From: Ken Argent
Sent: 23 January 2014 14:43
To: Gary Peck; 'helen.tier@environment-agency.gov.uk'
Subject: FW: 136 Upper Shoreham Road, Shoreham-by-Sea (AWDM/1483/12)
Attachments: Construction Drawing Issue Sheet 10.pdf; F16242 500a Drainage Layout P5.pdf; F16242 502 External Levels Layout P2.pdf

PROJECT : 136 Upper Shoreham Road

DRAWING TITLE: BELOW GROUND DRAINAGE LAYOUT OPTION 2

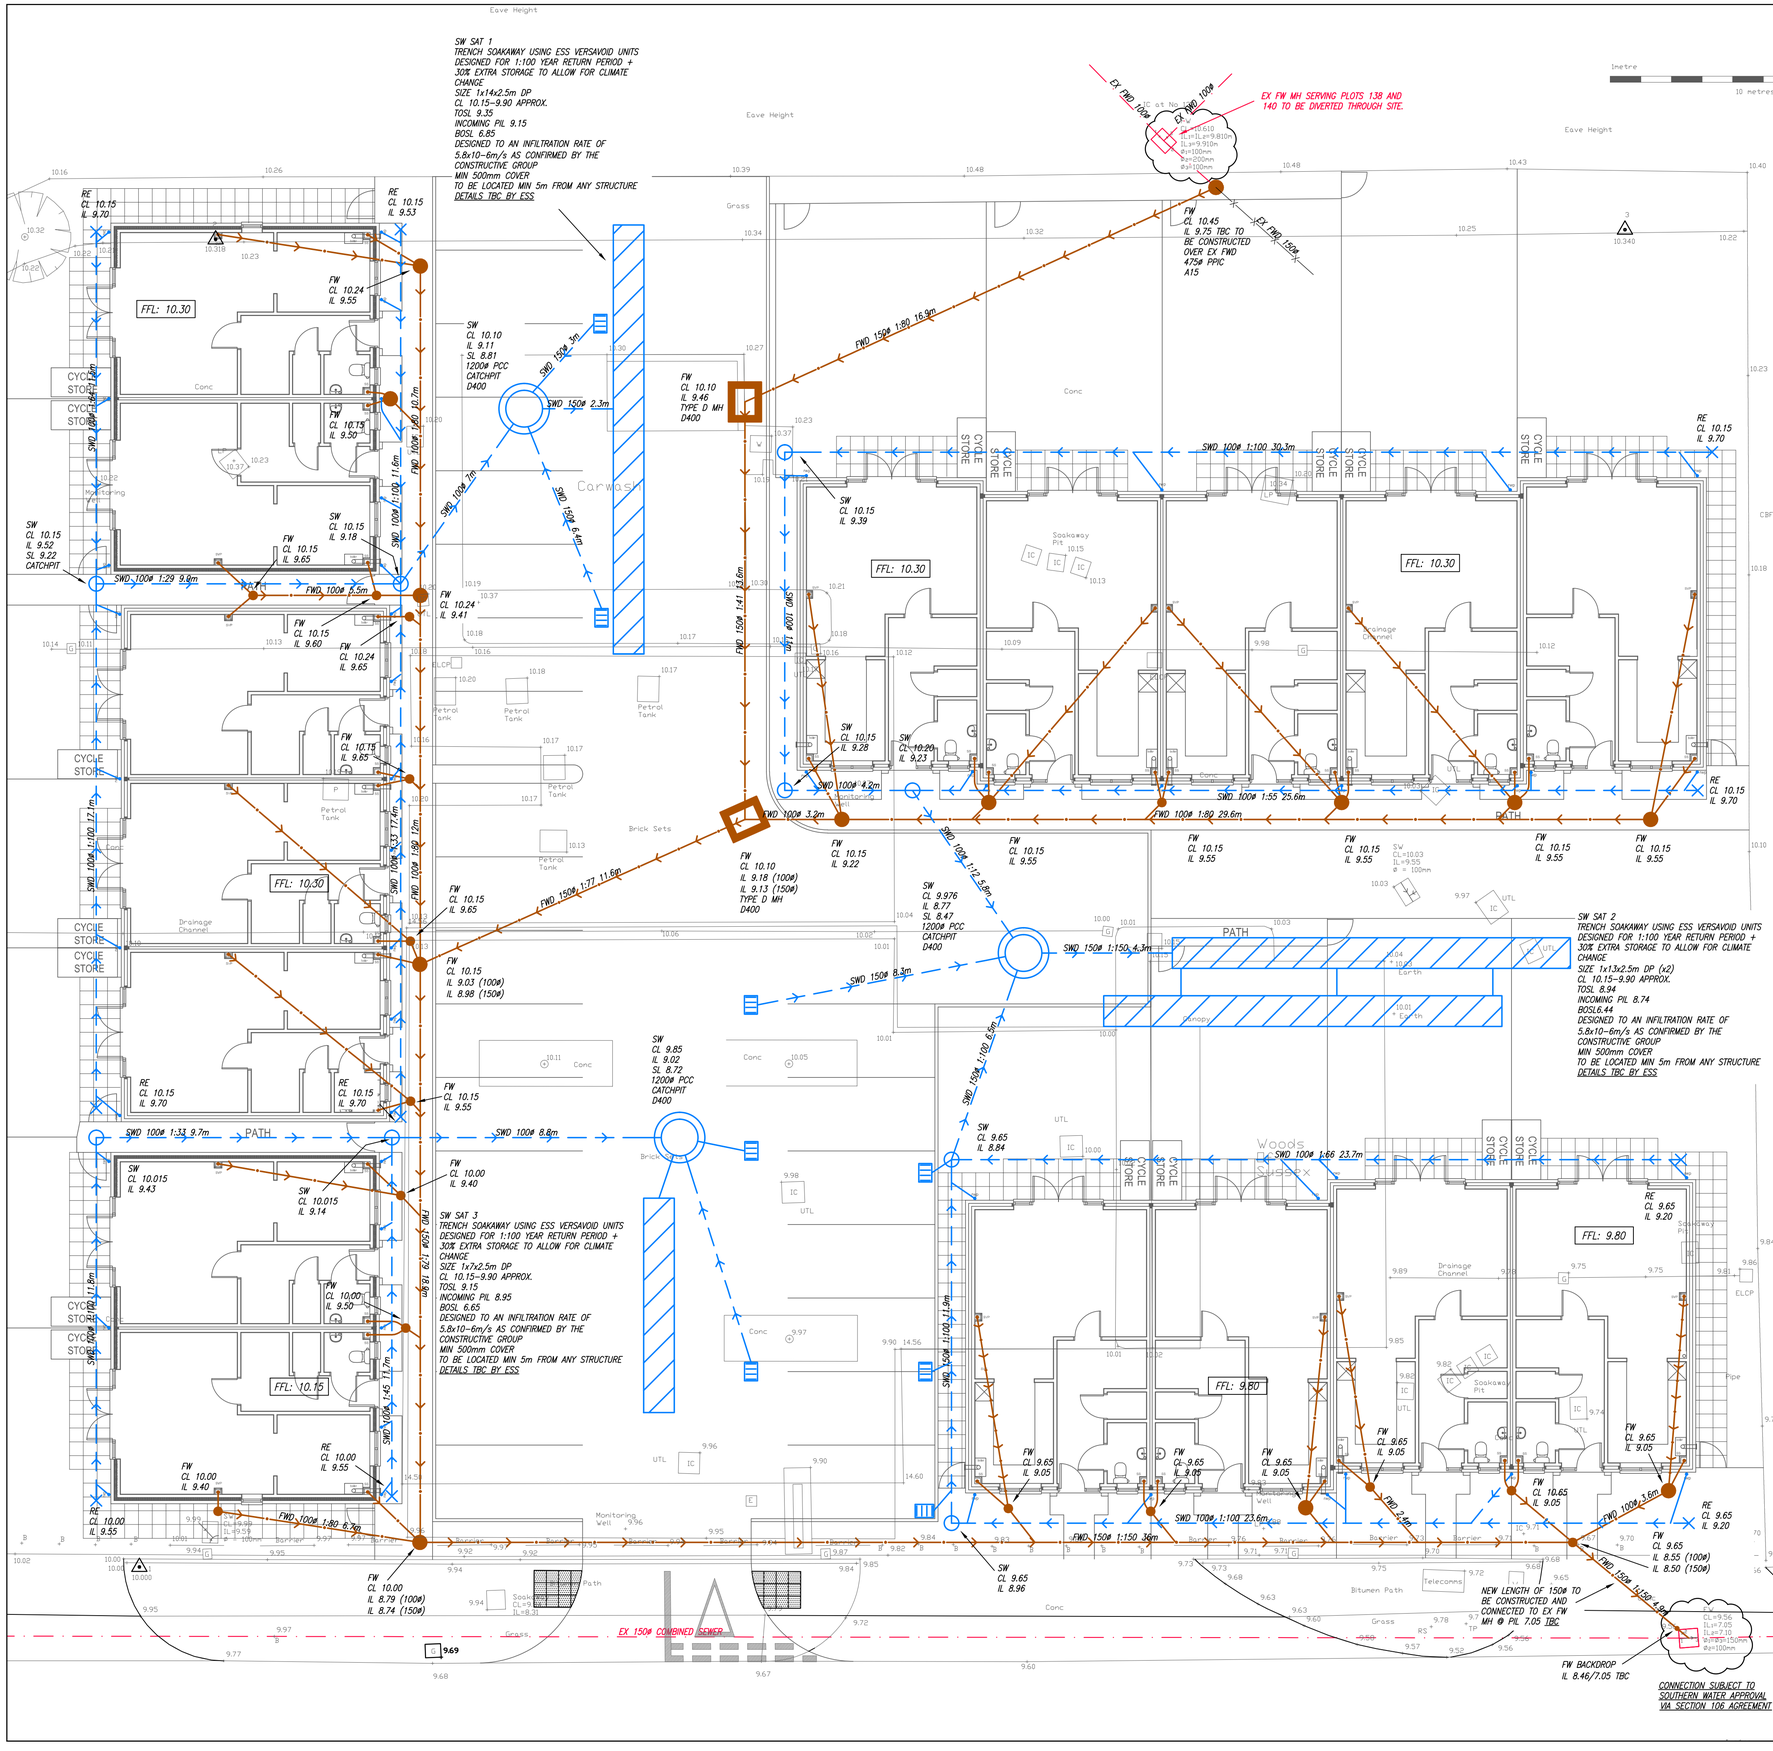
Whilst the soakaways proposed will cope with the runoff as designed I cannot suggest that Conditions 8 and 21 are satisfied, as these planning conditions clearly state infiltration i.e. soakaway percolation is not permitted and the proposals presented contravene those conditions
